Proposal #15: 4333-05-71, WISC 20180 047
CTH BB, CTH B – Norman Rd
E Twin River Bridge & Approaches
CTH BB
Kewaukee County

This is Addendum No. 01, which provides for the following:

Addendum No. 01
 ID 4333-05-71
 Revised Sheet 75
 January 8, 2018

STRUCTURE B-3I-100

75

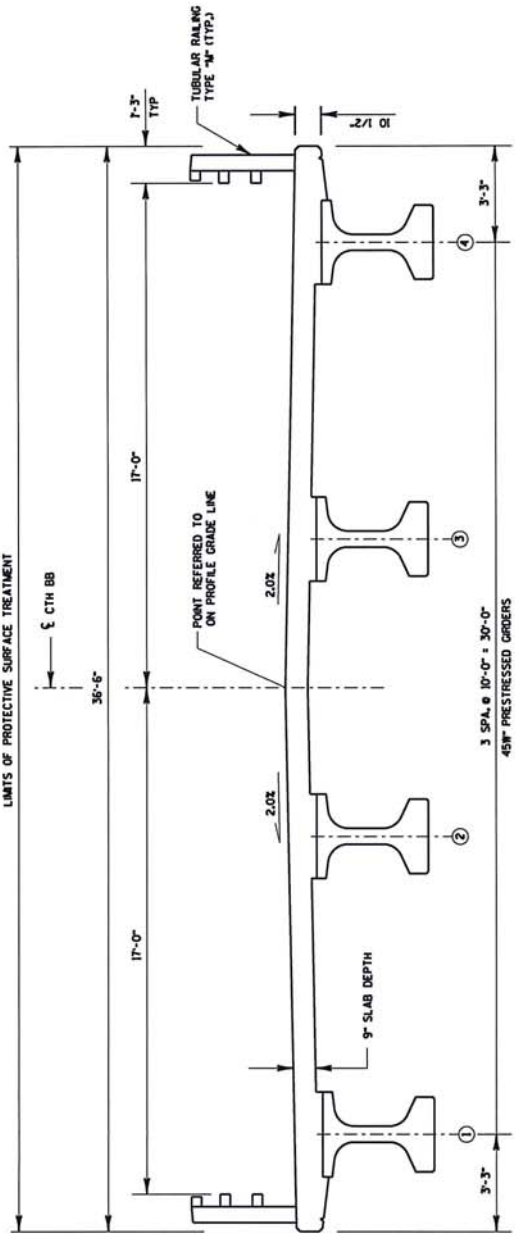
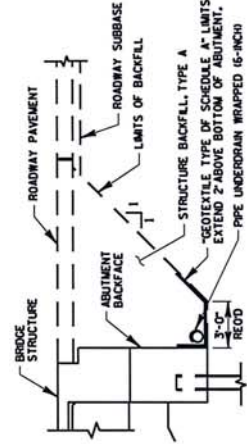
Revised Plan Sheets	
Plan Sheet	Plan Sheet Title (brief description of changes to sheet)
75	Schedule of Quantities Table has been Revised

210.1500	BACKFILL STRUCTURE TYPE A	TON	184	184		368
502.0100	CONCRETE MASONRY BRIDGES	CY	39	39	121	199
502.3200	PROTECTIVE SURFACE TREATMENT	SY			384	384
